2009 Corvette Z06 and ZR1: GM TechLink

Article: Oil System Changes - LS7 and LS9

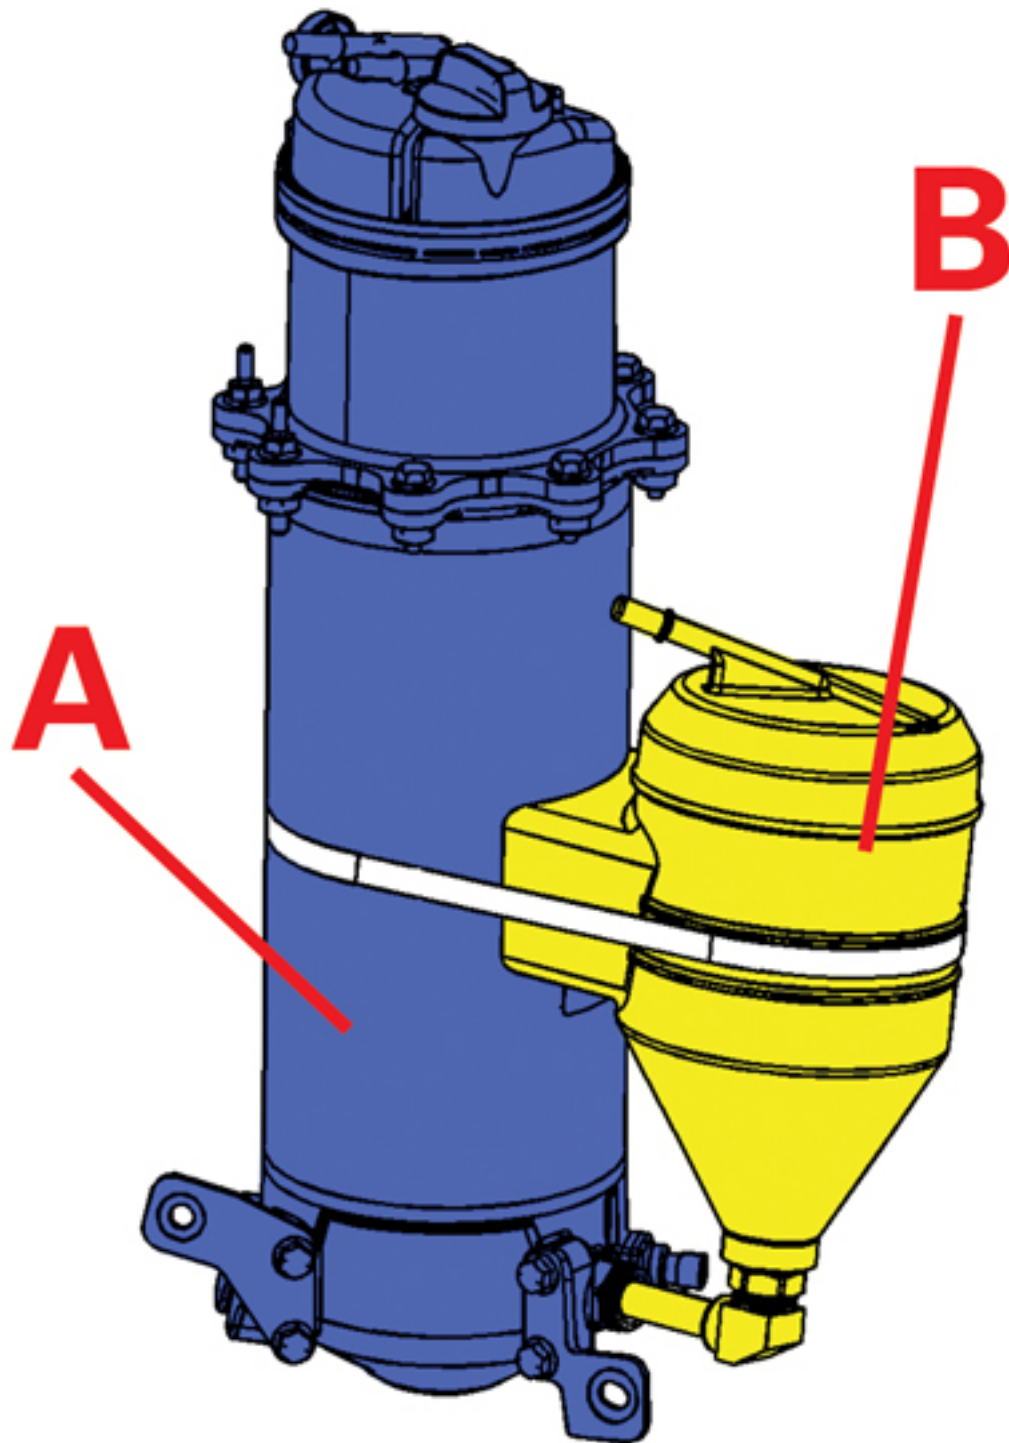
For both engines, the oil reservoir has been redesigned to increase the oil capacity of the system. Under extreme cornering loads such as experienced on a banked race track, extra oil capacity ensures that there is sufficient oil in the reservoir to avoid the ingesting of air due to slosh. A second tank is connected to the main tank by tubing (fig. 6) .

A Original reservoir

B Added capacity

Due to the revised oil reservoir, on both engines the oil capacity is now 10.5 quarts instead of 8.0 quarts, but otherwise the oil change procedure remains the same. Remember, there are two drain plugs in the oil pan. The one on the front of the pan drains the external reservoir and hoses. The other plug near the oil filter drains about a quart of residual oil from the pan. Refer to SI for details.
